Quality Notes 078400 Post Tensioned Slab Penetration - 01 08-07-2018

For Post-Tensioned Concrete Slab Penetrations:

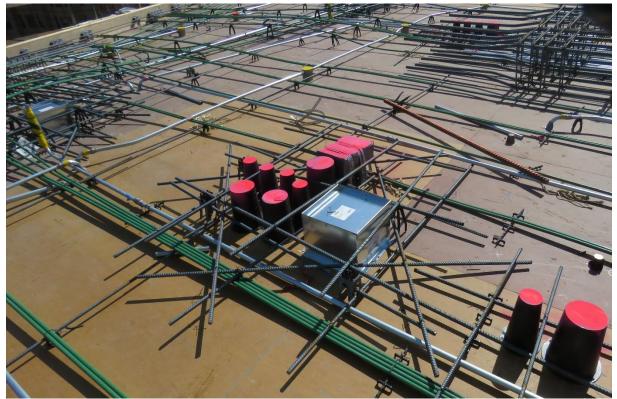
When installing pre-manufactured holes in the slab, we must review the entire hole that is created in the slab, make sure that it falls completely with-in the stud framing (not the drywall).

Is the hole is tapered? Does the installation allow for construction tolerance?

The hole is extending over the fire rated wall stud thickness.

in a 1-hour 4 7/8" thick wall...the studs are only 3 5/8" wide. In a 2-hour 6 1/8" thick wall...the studs are only 3 5/8" wide. In a 1-hour 7 1/4" thick wall...the studs are only 6" wide. Review the stud width when placing the holes.

Will need to contact the stud manufacturer or fire stopping manufacturer for a correction
